City of MISSION

AGENDA

PROJECT NUMBER / TITLE: Case # 16-01

REQUEST: Re-Plat of a portion of Mission Vale Subdivision

Preliminary Plat
Lots 3 & 4 & West 15 feet of Lot 5, MISSION VALE
A Subdivision in the City of Mission, Johnson County, Kansas

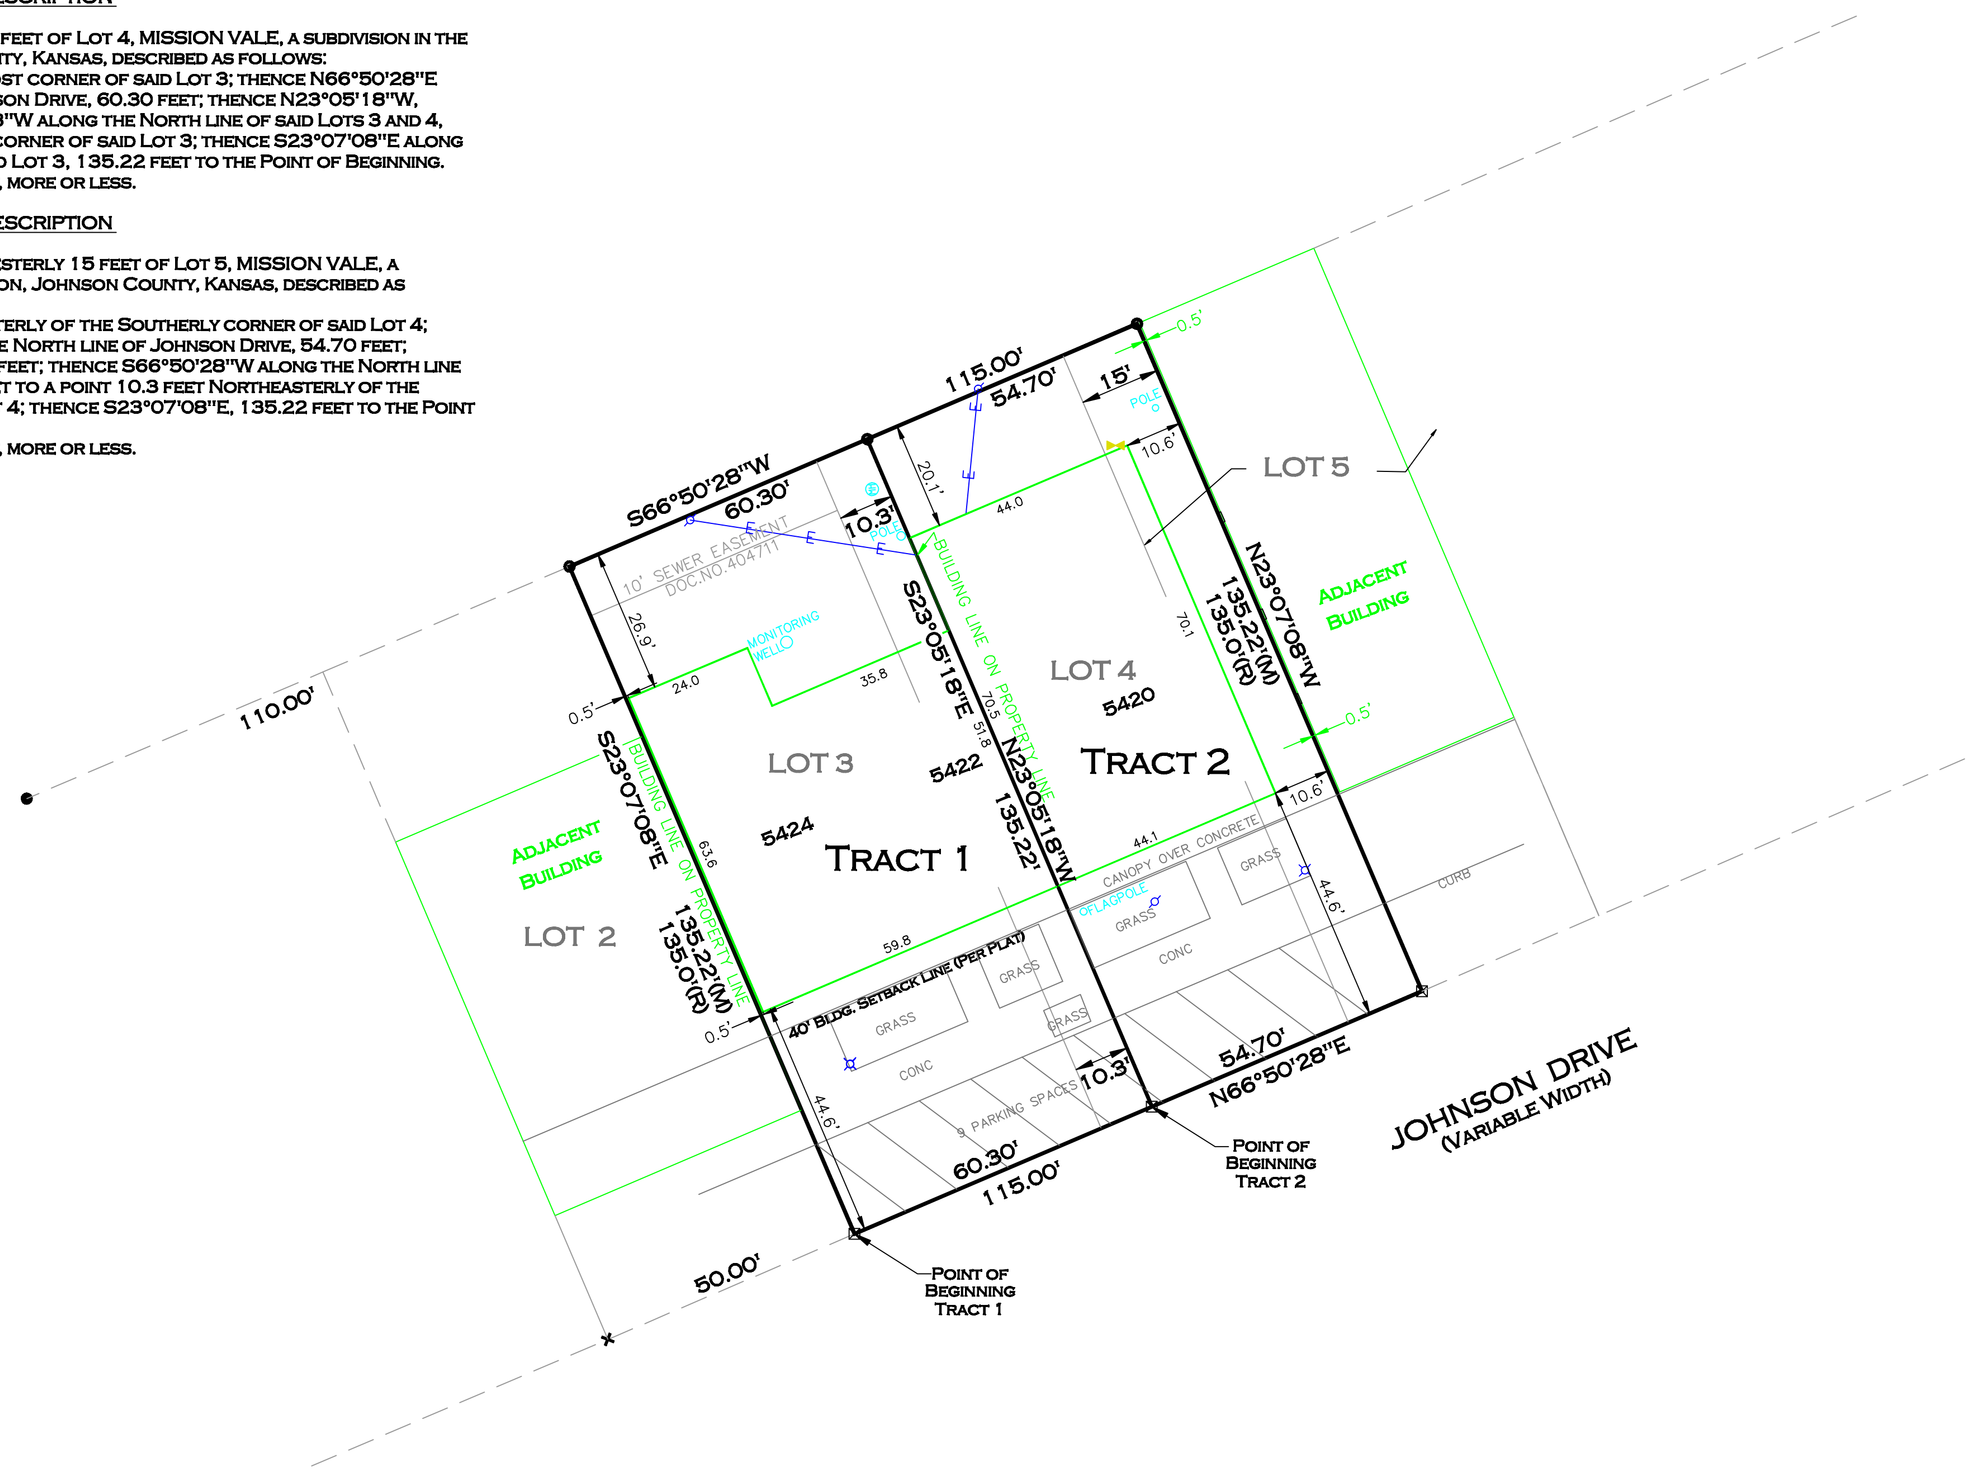
-All of the requirements of 440.250-Submission of Final Plat have been satisfied. Minor typos/corrections are needed to the title, labels, dedication, and drawing of the plat.

1) Correction of any minor text changes prior to recording including removal of the 40' building setback line, dedication of drainage and utility easements to the City, owner signature reference, lot naming, plating naming, and plat title.

Staff Recommendation
Staff recommends the Planning Commission approve the replat Case # 16-01 for the subdivision of land to be known as "Lots 3 & 4 & West 15 Feet of Lot 5, Mission Vale" with the following condition:
